**Subject: Docket Nos. 50-361 and 50-362
Proposed Technical Specification Change Number NPF-10/15-516
Reduce the Minimum Boltup Temperature for Reactor Vessel Head
Bolts When They Are Tensioned
San Onofre Nuclear Generating Station Units 2 and 3**

AMENDMENT APPLICATIONS 199 AND 184

(PCN-516)

**DESCRIPTION AND SAFETY ANALYSIS
OF PROPOSED CHANGES NPF-10-516 and NPF-15-516**

SONGS 2 COOLDOWN RCS PRESSURE/TEMPERATURE
LIMITATIONS UNTIL 20 EFY
Normal Operation

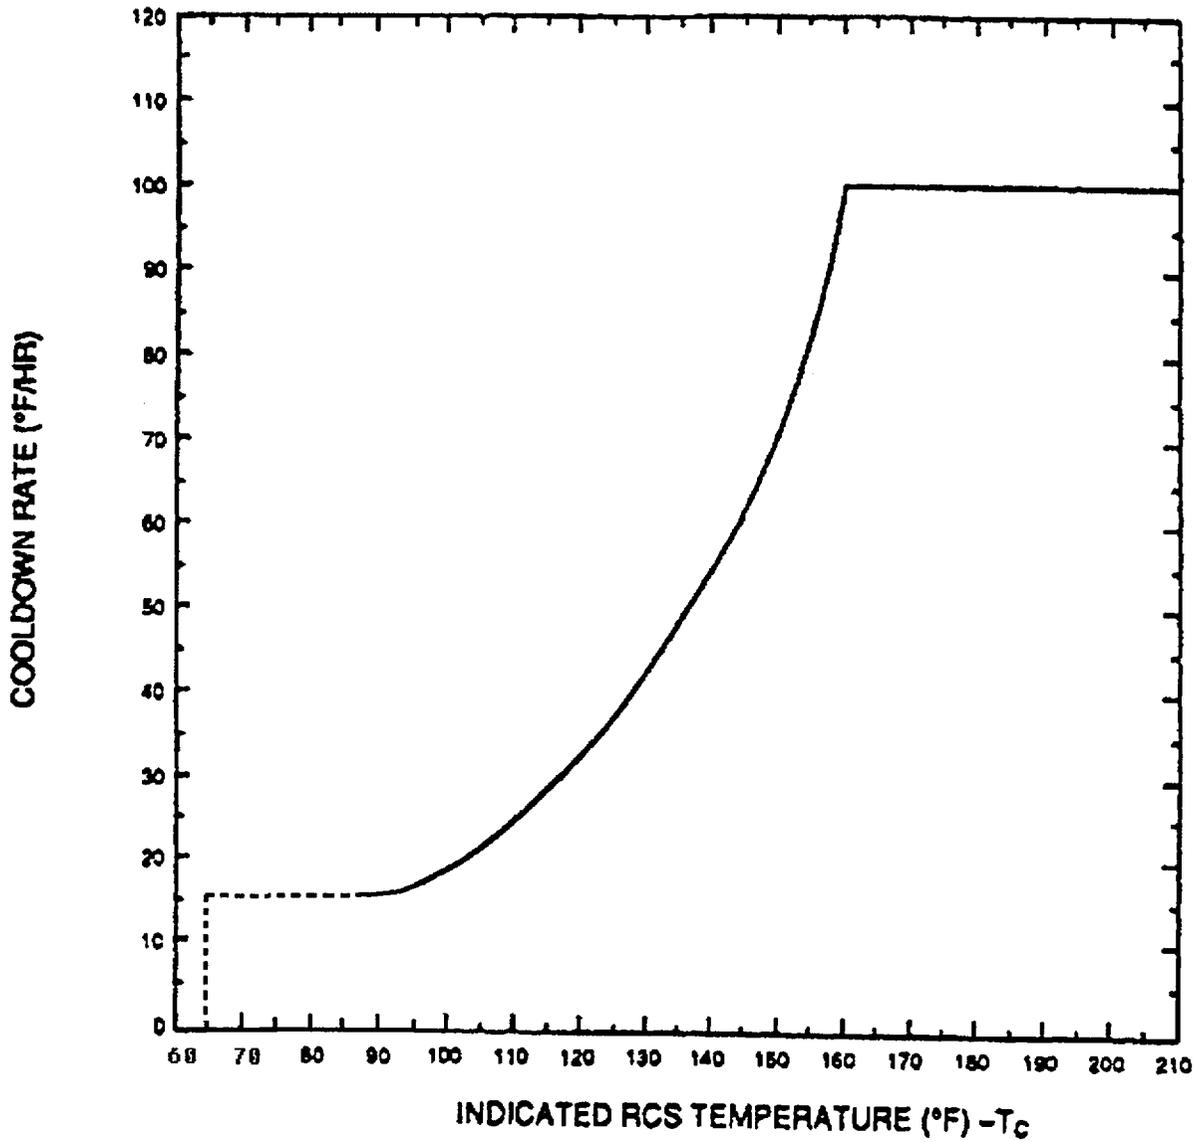
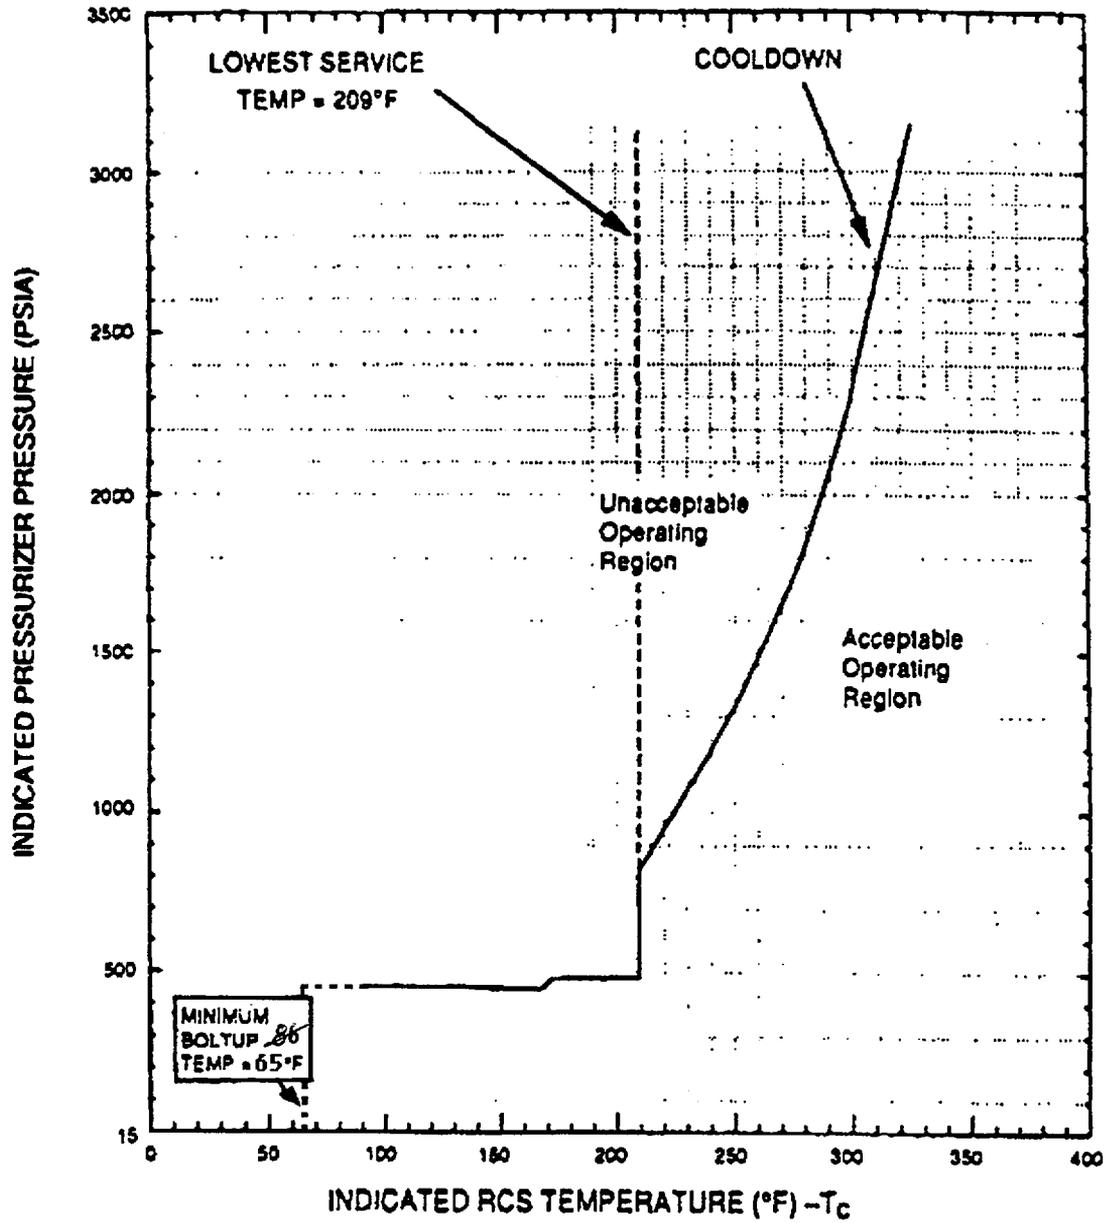
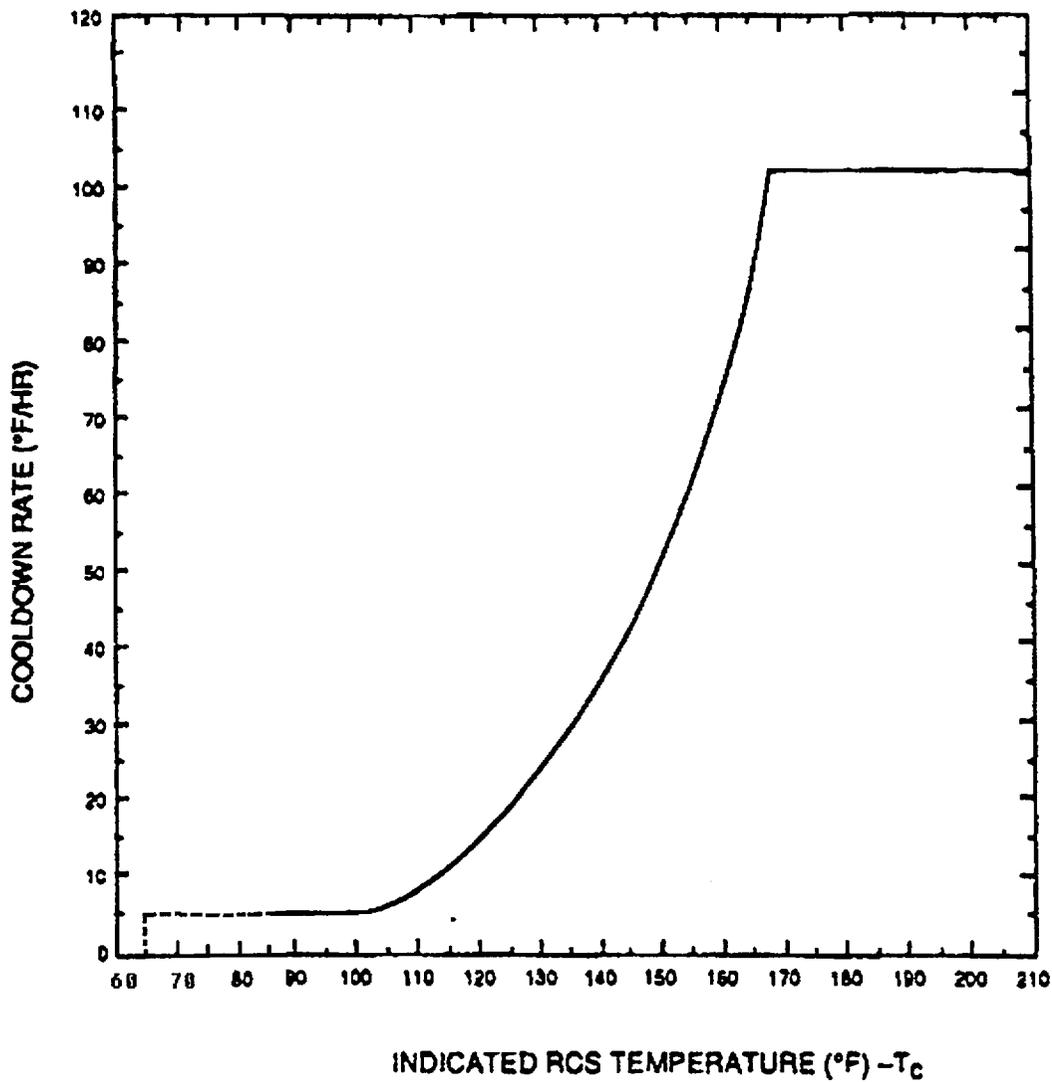
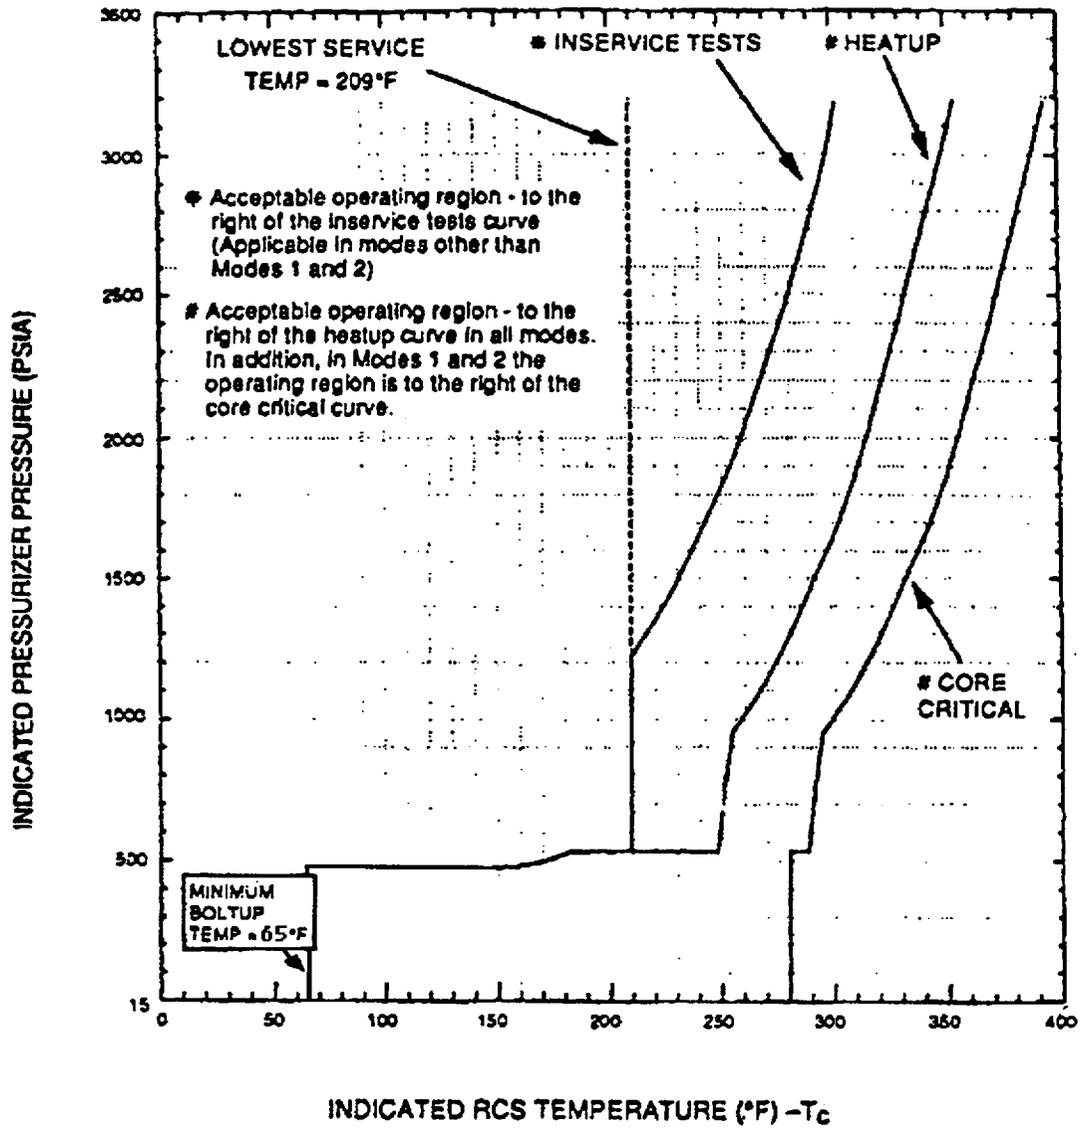
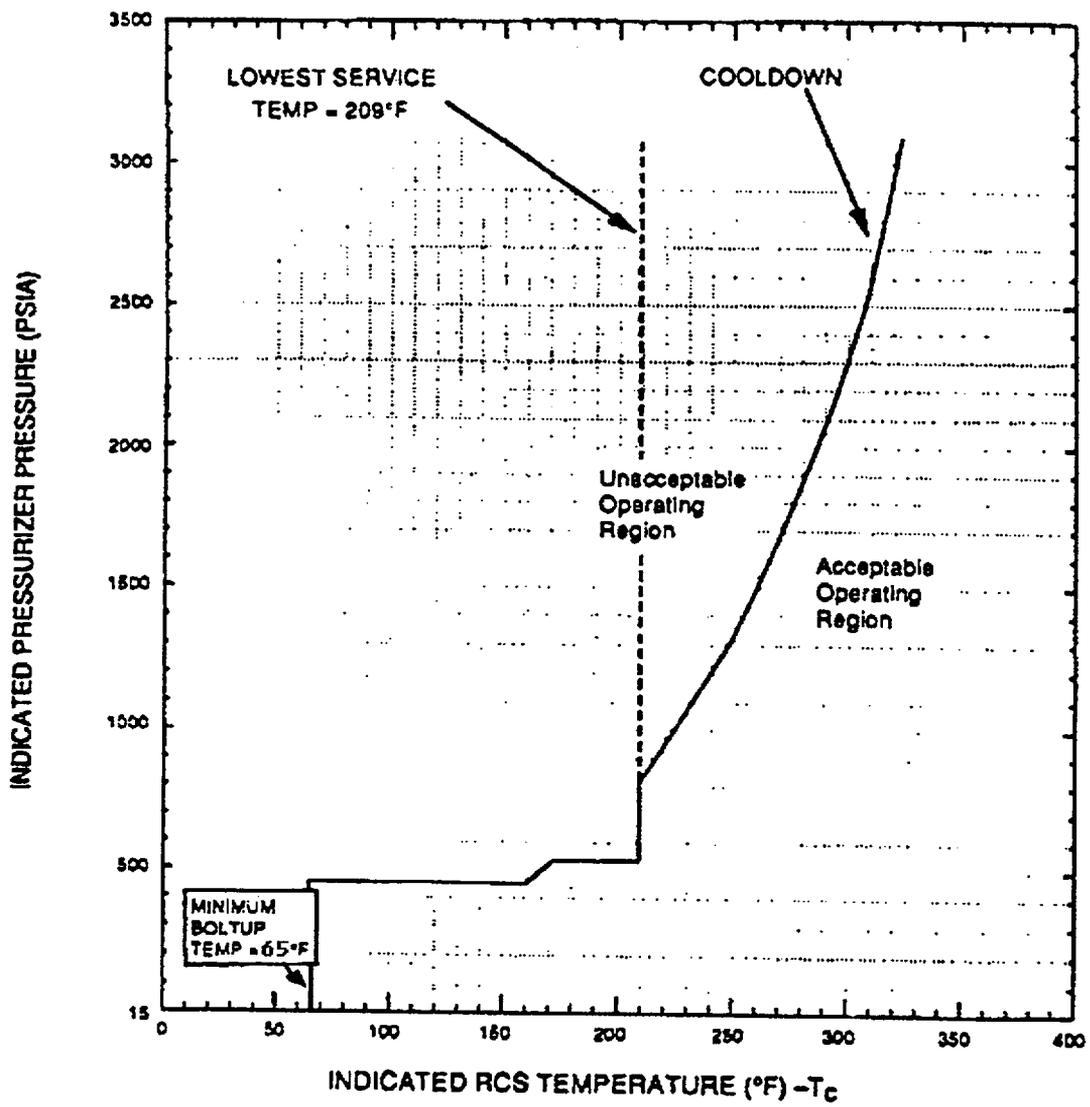
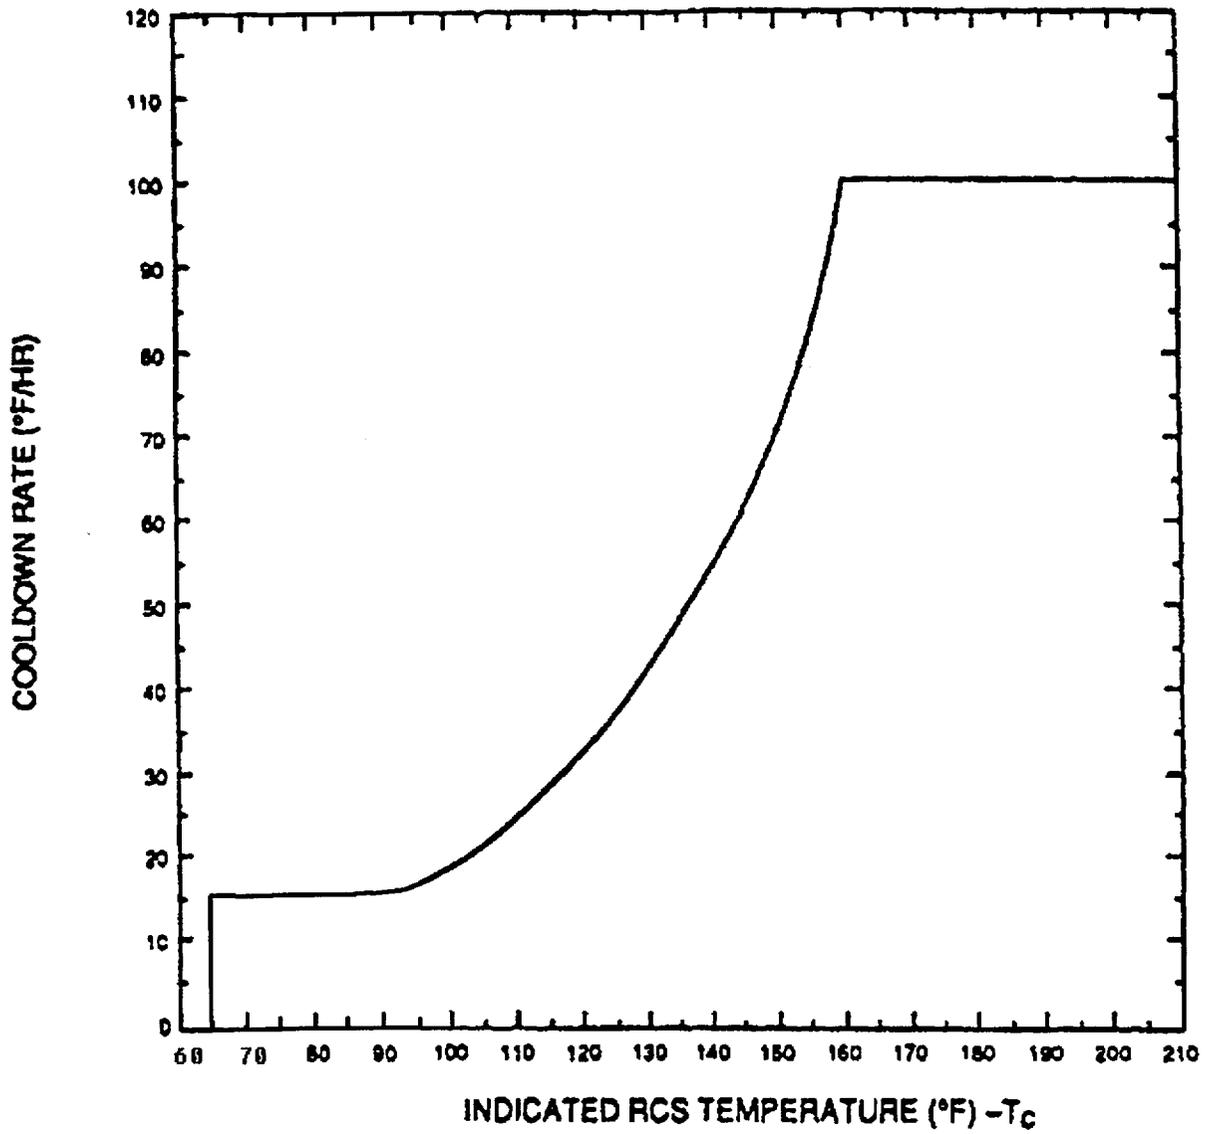
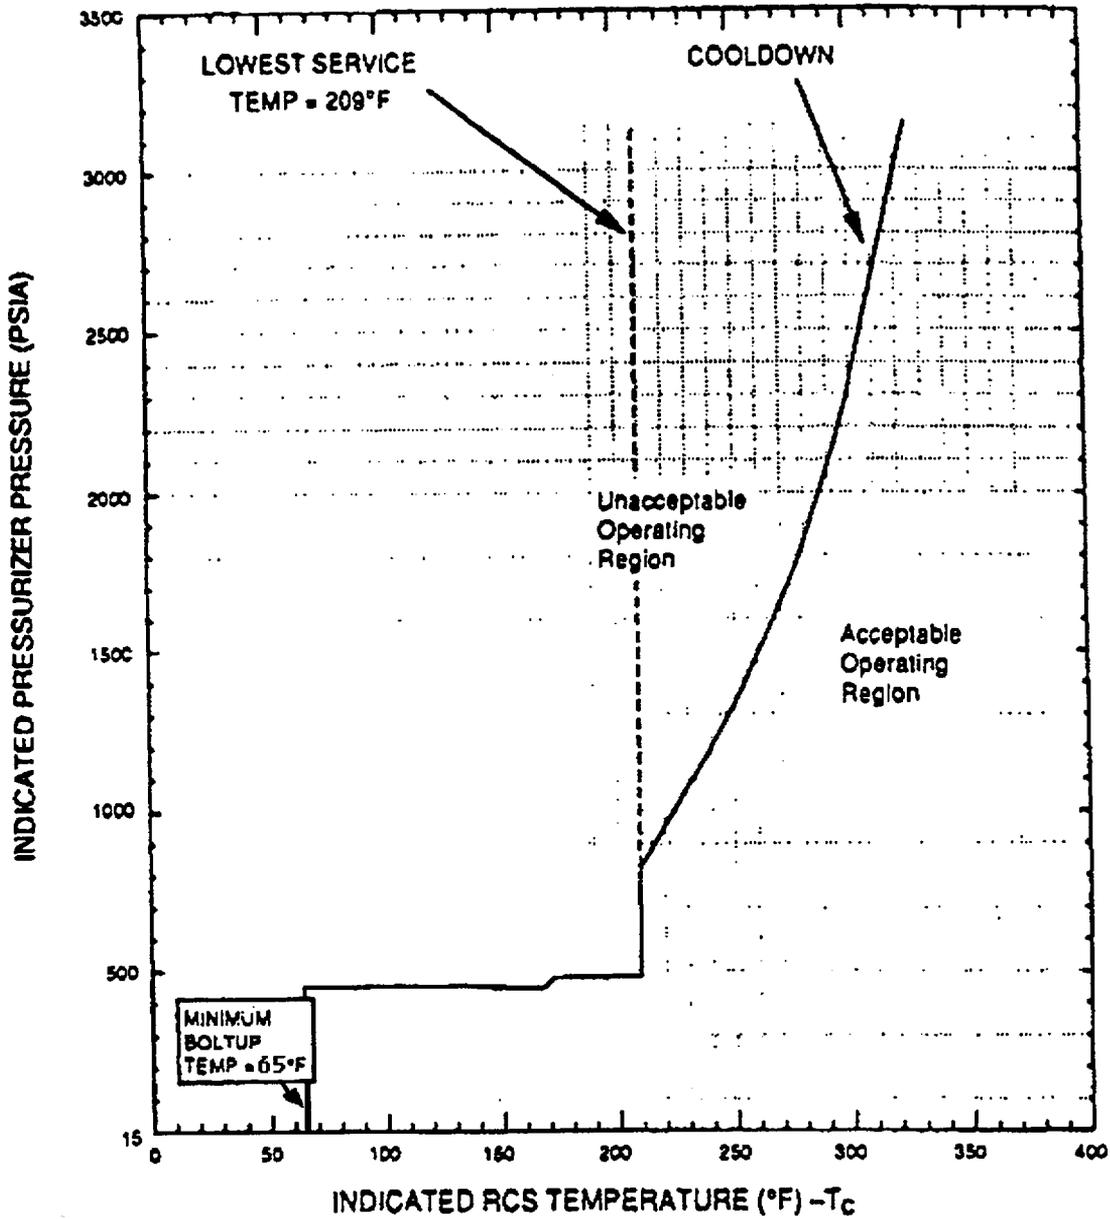
LCO Conditions "a" and "d", a footnote at page 3.4-5 and Figures 3.4.3-1 through 3.4.3-5 will be revised to reflect this new value. The Pressure-Temperature curves on Figures 3.4.3-1 through 3.4.3-5 will be extended from 86°F to 65°F. During operation at temperatures between 86°F and 65°F, the pressure limit change is negligible. Additionally, the TS bases will be updated to reflect the basis for the MBT of 65°F.
